Re: Permit #SFD2310-0022

I had spoke to you earlier today about 188 Hobby Rd.

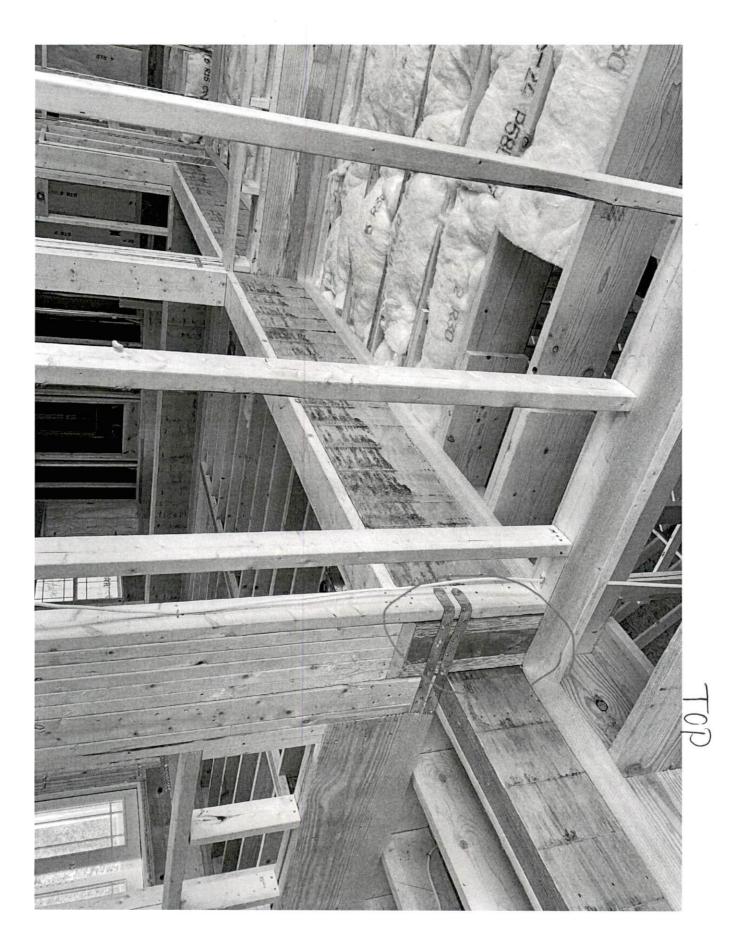
I cannot see that there is 3 lvls. Looking at the right end of the beam it appears that there is a Lvl block that is wider than a lvl placed between the outside lvls similar to how beams are packed out. If there is a second full length lvl behind the block then it is shorter and I will have to look to see if the jacks are large enough under it to be able to have the correct bearing. A 2x8 was nailed to the top and bottom of the beam making it impossible to see the plies from under or above it also. Do you have a superintendent or anyone over seeing the project that could meet me out there at the next inspection so that we can resolve this and move along? I am normally out that way first thing in the mornings. I have attached a photo to show what I am describing. Thanks

Yes because I was trying to explain to Justin that there is no engineer letter needed because there is an engineered calc sheet that states we only need 2 LVLs we have 3, so we do not need a letter explaining the cut LVL as it is not needed per the engineered calc sheet. It is an extra LVL. That's why I had called and left him a message trying to get that information to him. Thank you so much for you help.
